**SPECIAL ANALYSIS:
DISPOSAL OF ETF ACTIVATED CARBON VESSELS IN SLIT
TRENCHES AT THE E-AREA LOW-LEVEL WASTE FACILITY**

Design check from B.T. Butcher

**DESIGN CHECK INSTRUCTIONS AND REVIEWER COMMENTS FOR SPECIAL ANALYSIS OF
ETF CARBON VESSELS IN SLIT TRENCHES**

Design Check for Special Analysis of ETF Carbon Vessels in Slit Trenches

Appendix A. Flux and Concentration Plots

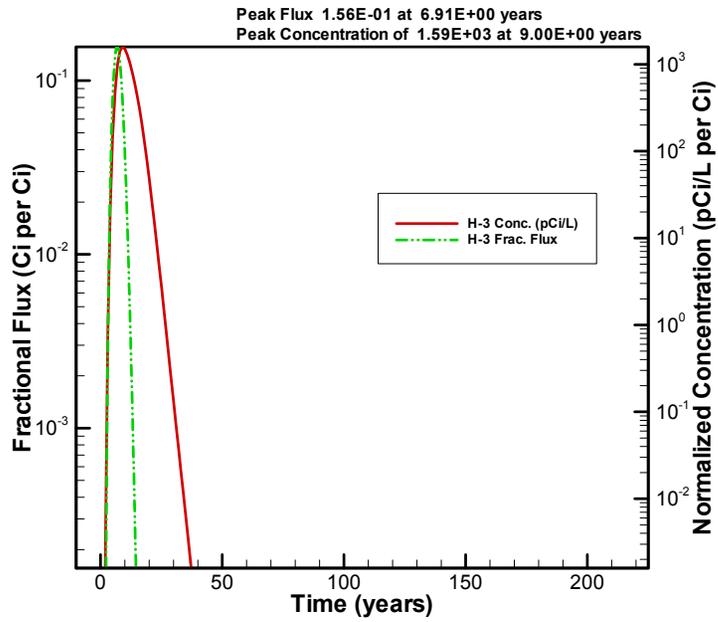
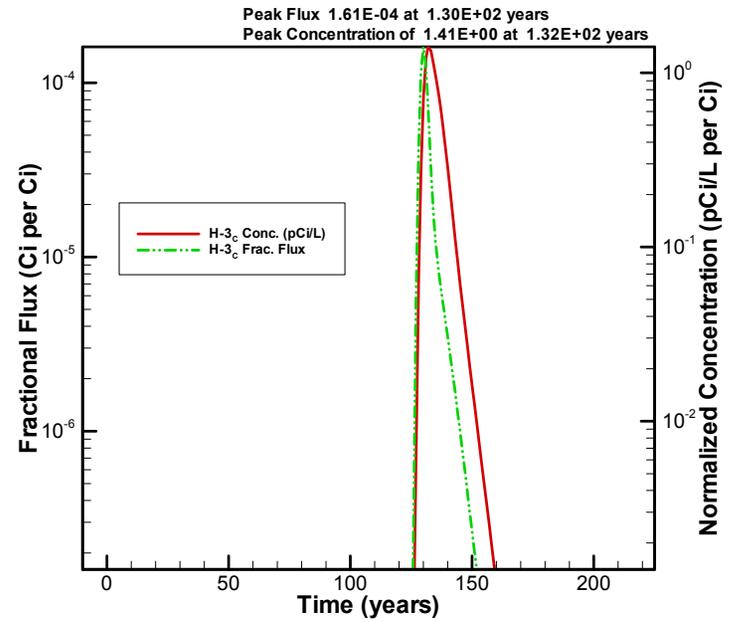
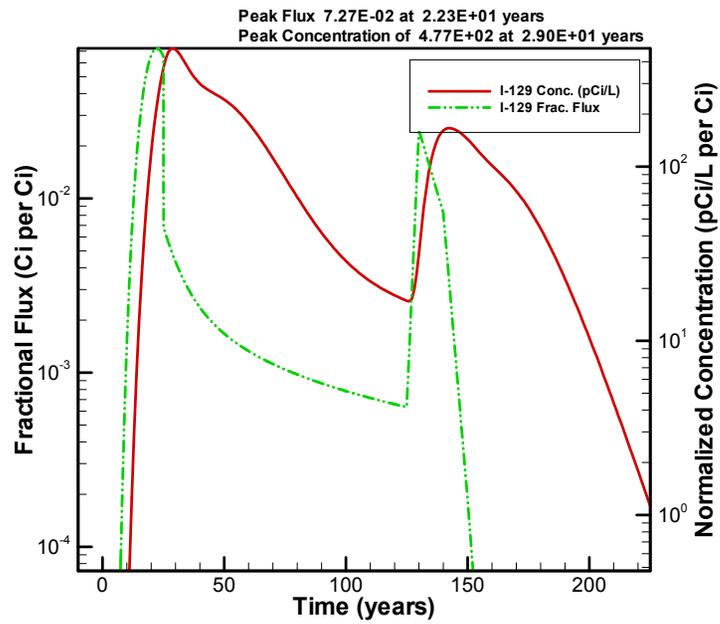
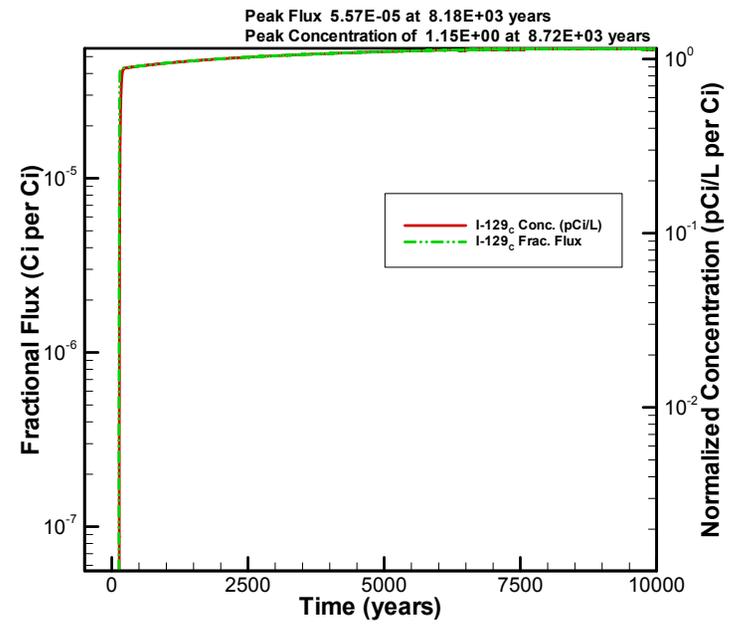
Peak concentrations, fluxes and times from the figures in Appendix A were compared with Table 1 values and were correctly transcribed. Values from modeling output showing fraction remaining with time when starting with one curie of each nuclide were compared with tables 2, 3 and 4 in the report. All were correct.

- For each nuclide, the general pattern well concentrations were found to match the general pattern of the fluxes.
- For H-3, the plots for H-3_C are similar to those of H-3 except that the H-3_C curves are delayed (right-shifted) by ~125 years.
- For I-129, the plots for I-129_C do not exhibit any peak due to the high new Kd. The plots for I-129 display double peaks for both concentration and flux.
- Check the plots for generic waste vs. PA results:

- The current special analysis and PA show identical results of peak fluxes and concentrations:
 - Fractional fluxes:
 - 1.53E-1 @ 6.91 years (H-3)
 - 7.27E-2 @ 22.3 years (I-129)
 - Normalized concentrations:
 - 1.59E+3 @ 9 years (H-3)
 - 4.77E+2 @ 29 years (I-129)

- In general, the plot trends for generic waste tend to agree with those shown in the PA report. An accurate comparison cannot be established since plots are displayed in different scales (i.e., larger time scale in Special Analysis; log scale for fluxes and concentrations in Special Analysis vs. linear scale for those variables in PA).
